MEMORANDUM

From:	JP		
Service	WBC Highways	App No:	251470
Address:	1 Halstead Close, Woodley, Wokingham, RG5 4LD.		
Proposal:	Full application for the proposed erection of first floor side extension following subdivision of existing dwelling, associated parking and amenity land.		
Type of Development:	Minor Dwellings (1-9)		
Site Visit Made:	Yes/No

Reason for refusal

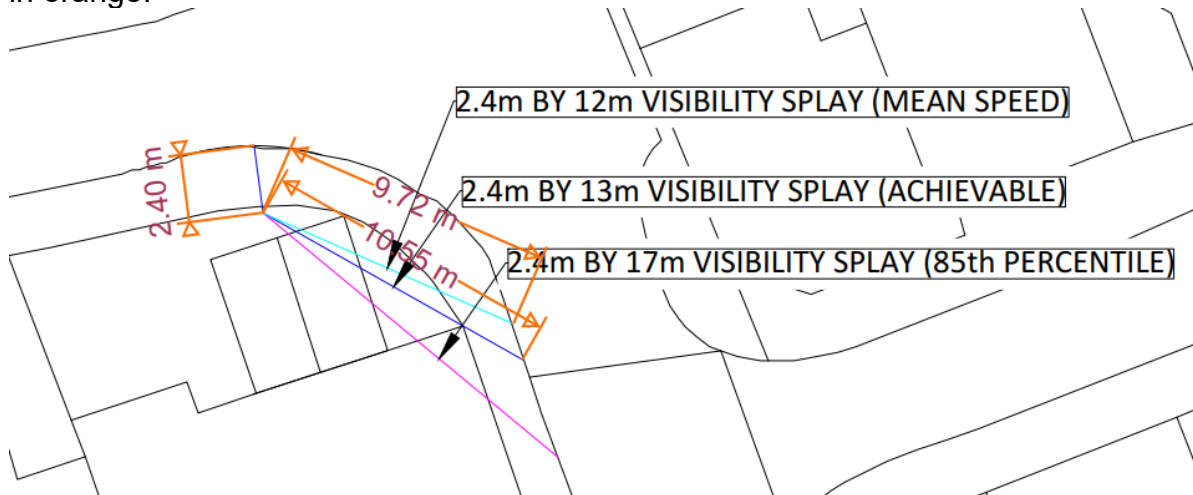
While SSD is generally assessed on its 85th percentile speed, the MfS2 suggests that a minimum X distance of 2m and a reduction in Y distance below recommended levels (85th percentile speed) can be acceptable unless there is local evidence to the contrary. The appellant suggested that the site is situated at a lightly-trafficked street with two-way traffic between 106 and 142, daily.

Despite it is reasonable to consider this as a slow-speed situation and accept reduction in X distance, the acceptance of SSD based on its mean speed is unreasonable for this site.

The footway along the southern/western side of Halstead Close connects to the site access of Woodford Park, where vulnerable pedestrians (e.g. children) are anticipated. The Highways therefore expect visibility splays no worse than the existing to be achieved to the nearside edge of the carriageway in both directions.

Meanwhile, no sufficient justification has been provided that the adjustment for bonnet length is not required. In particular for short SSD, the distance between the driver and the front of the vehicle account for a significant portion. Therefore, the SSD adjusted for bonnet length has to be applied.

The Highways remeasure the submitted drawing (Ref: R-25-0169/HY02) as marked in orange.

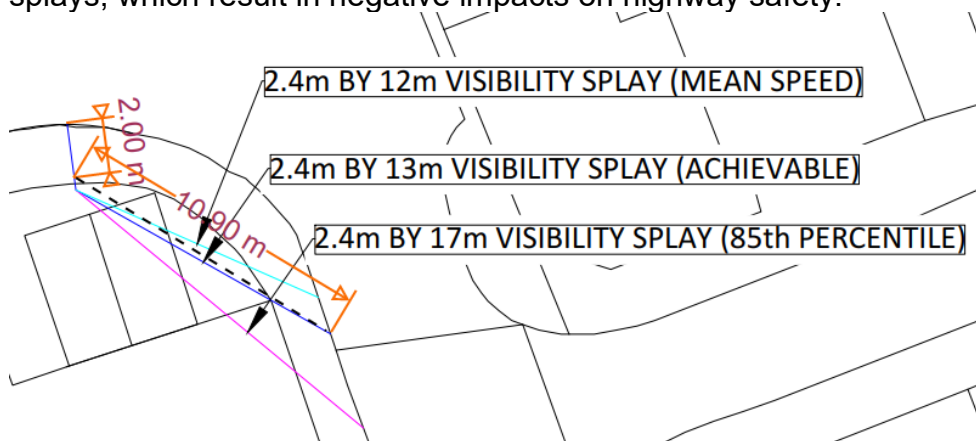
Regardless of the visibility splays to assess on the SSD for mean speed, the proposed measurement for a maximum 2.4m x 13m visibility splay to the east is inaccurate and unachievable.

It is noted that the maximum achievable visibility splay to the east is circa 2.4m x 10.6m, which is aligned with LHA estimated visibility splay (2.4m x 10.3m) during the planning application stage.

The Highways have also assessed the visibility based on reduced X distance (in black dotted line), which a maximum of 2m x 10.9m visibility splay can be achieved. This does not meet the required visibility splays nor retaining the existing visibility splays, which result in negative impacts on highway safety.
